Product / Process Change Notification (PCN)

PCN Number: PCN_FeAFB LFS_20250101

Affected Series: WE-AFB LFS

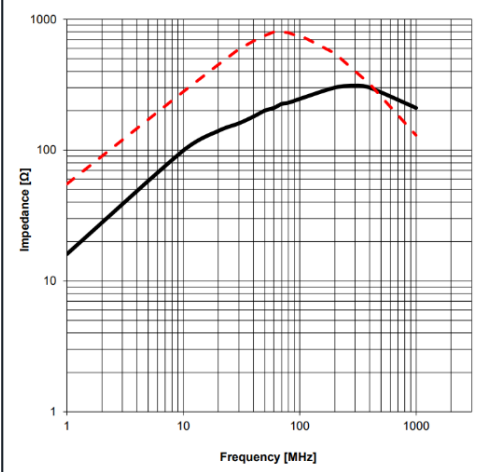
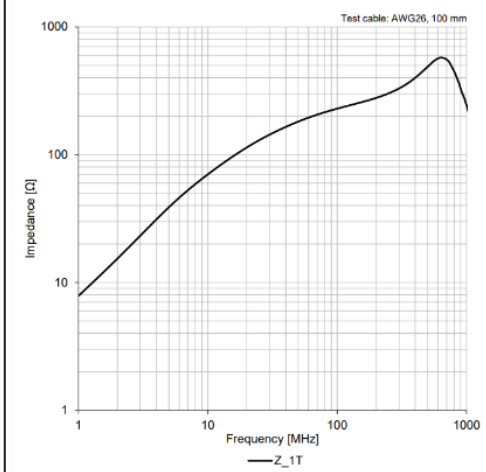
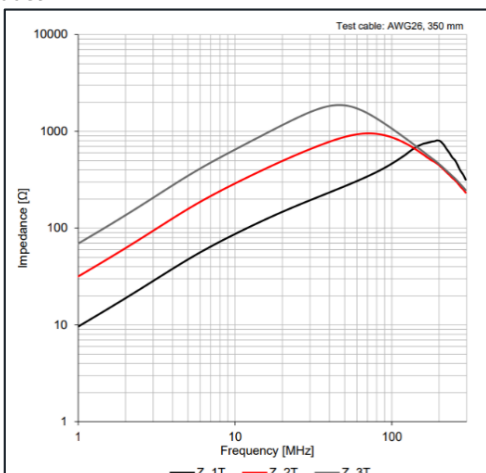
3. The visualization of chart for the “**Typical Impedance Characteristics**” changes. The used type of cable and cable length is shown in each chart.

Before change:	After change:
<p>Showing only one graph with 1 turn (1T) and 2 turns (2T) impedance curves.</p> 	<p>Showing a graph for the 1 turn (Z_1T) impedance curve with the shortest possible cable length according to the product.</p> 
<p>Showing no graph with 3 turns impedance curve.</p>	<p>Showing a graph for 1-3 turns (Z_1T, Z_2T, Z_3T) impedance curves with the shortest possible cable length, which is required for 3 turns according to the product.</p>
